To: Atmel

EPSON TOYOCOM CORPORATION
QD QUALITY ASSURANCE GROUP**MC-306 (32.768 kHz) Quartz Crystal Circuit Evaluation**

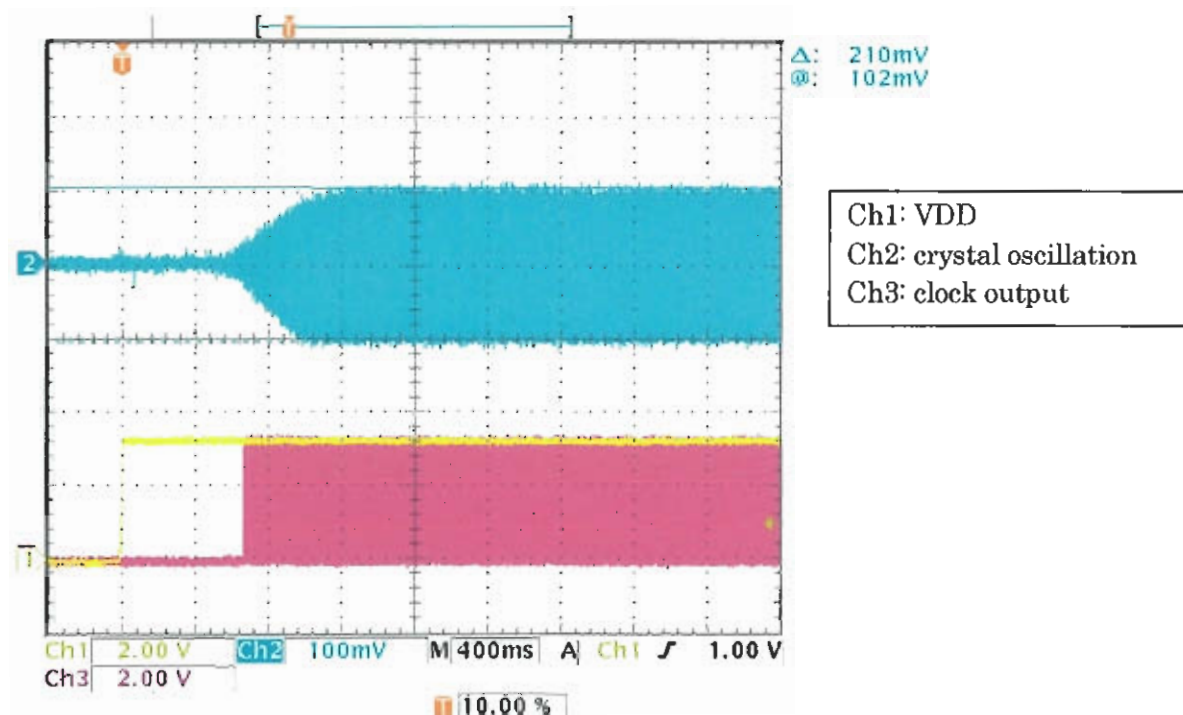
(3) Oscillation start up time.

Measurement condition : VDD=+3.3 V , CG=CD=6 pF , Ta=+25 °C , PCB No.1

Measurement result : Data were shown in the table and waveform figure.
